DCR PHOENIX HOMES

LOT #311

PATHWAYS 2

520 - KLONDIKE

MAIN BATH VANITY

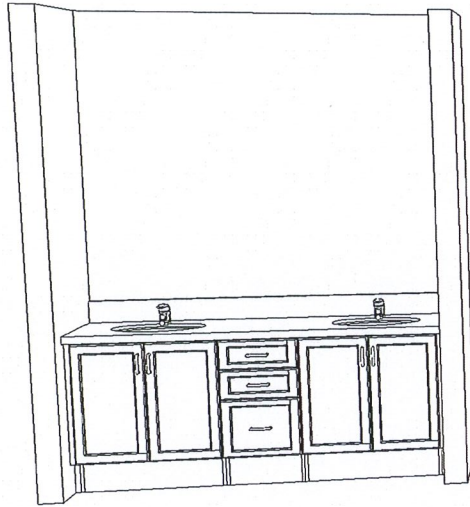
NOTE:
CABINETS MODIFIED
TO ACCOMMODATE SECOND SINK.

ENSUITE VANITY

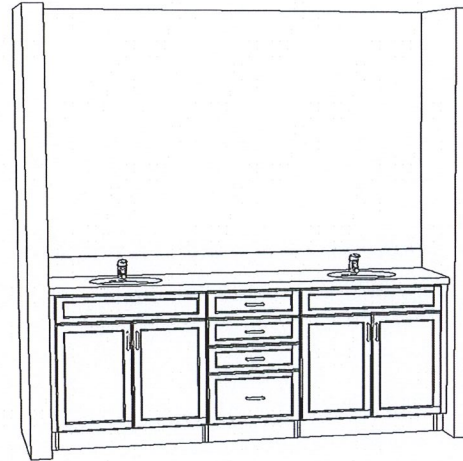
NOTE:
ENSUITE RE-DESIGNED.
VANITY LENGTH INCREASED BY APPROX. 18"
VANITY HEIGHT INCREASED TO 34.5" H. + COUNTER TOP
